Access Compliance Report Public Rights-of-Way (Pedestrian Signals)

Main Street: **BEACH_BLV** Cross Street: **MCFADDEN_AVE** Location: **SW**

ADA ID: **SGRK211005145253** Signal Type: **One Push Button-APS** Overall Compliance: **No** Severity Scores: **BTN 1: 25** **BTN 2: N/A** **No BTN: N/A**

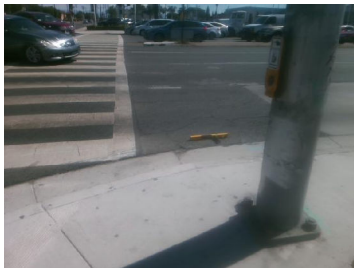
OC Std/PROW: **R404.2**

Possible Solutions: Remove and Replace Clear Space.
